Date August 8, 2016
Our reference n/a
Contact person S. T. Navalkar
Telephone +31 (0)15 27 83519
E-mail S.T.Navalkar@TUDelft.nl
Subject Response to reviewers

To
The Anonymous Reviewer 2
Wind Energy Science

Response to comments of Reviewer 2

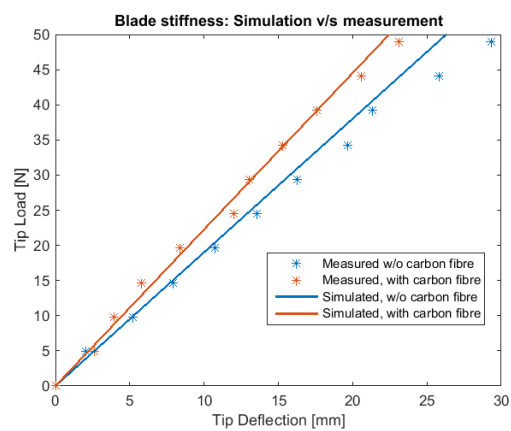
3. You affirmed that “Data-driven controller may be able to achieve greater optimality of performance without the excessive conservatism of the true robust design”; It seems you want to compare totally opposite methodology. Data-driven has no proof of robustness and/or optimality and the performance of the controller depend of the number of data-acquisition set you used to determine your controller. This methodology has advantages of deleted identification part and to be simple to use and implemented but does your non-linear system is not a linear piecewise system? Does you have some robust control methodology that you could use?

The authors agree completely with the reviewer that the data-driven strategy described in this paper has no proof of robustness or optimality, and depends strongly on the realisations of the data and wind speed during operation. In case one were to approach the controller design from a traditional robust mindset, one would be required to formulate an accurate linear parameter-varying or piece-wise linear description of the system, which would undoubtedly be subject to significant parametric and dynamic uncertainties. Formulating a robust controller based on such an uncertain plant description could yield a strongly conservative controller that is perhaps not able to achieve the maximum possible load reductions. The advantage of the IFT approach is that, besides being simple, it uses input-output data to tune itself to optimise a simple user-defined criterion. Since a feedforward approach is used, the IFT controller cannot destabilise the plant; in the best case, it could perhaps achieve load reductions that a conservative robust controller may not be able to reach.

This discussion will be repeated in the revised manuscript to clearly compare the proposed control strategy with the robust control approach.
